WARRANTY BULLETIN

WB12-31

DATE : NOVEMBER 2012	SECTION :	01 - Engine
EXPIRATION: NOVEMBER 2014		
SUBJECT : DIPSTICK REPLACEMENT- D13 US07 AND US10

WB12-31A

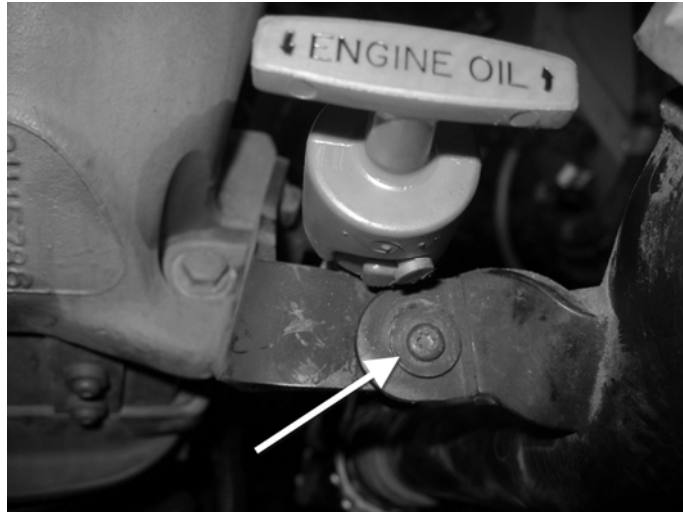
NOTE
<i>The safe oil level is slightly higher with the new dipstick. More oil will need to be added to the engine. Adjust the oil level to the new "MAX" mark.</i>

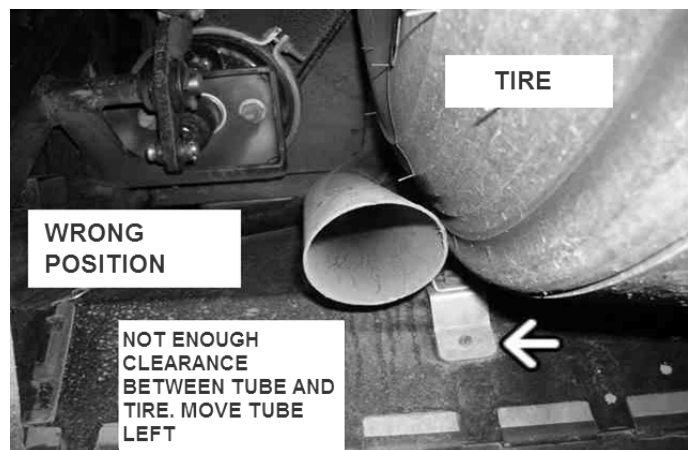
On the vehicles affected by this bulletin, the pre-heater exhaust tube may have been installed too close to the tag axle tire. Inspect tube position and make sure it has proper clearance with the tire. If not, move it away from the tire.

3. This is the correct position. Distance between tube and tire should be approximately 2 in.

4. Any other position less than 2in between tube and tire is wrong. Proceed to the next steps.

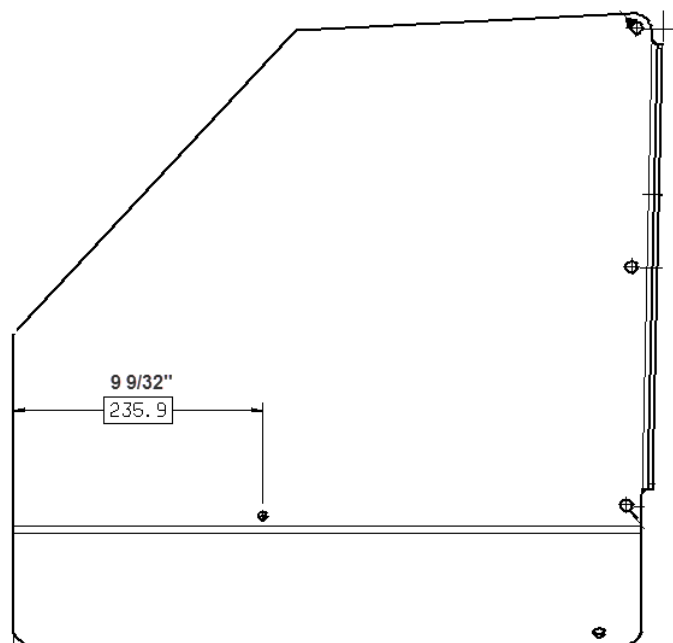
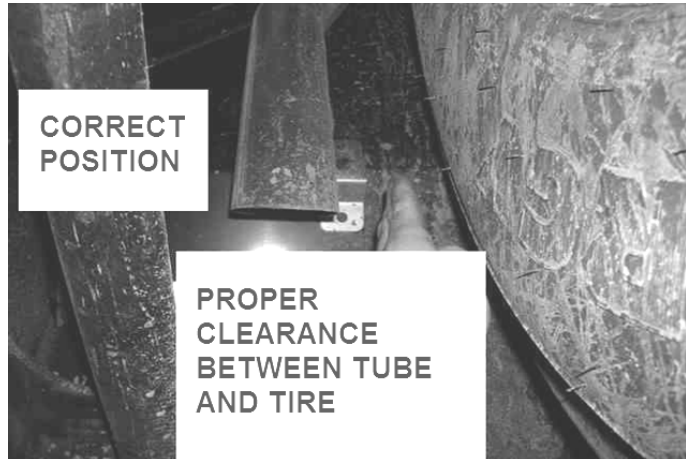
7. To help position the mounting bracket, there is a mark that indicates the proper mounting hole position on the plastic panel.

8. Secure at new position. Re-use mounting hardware.

9. The final position should look like this.
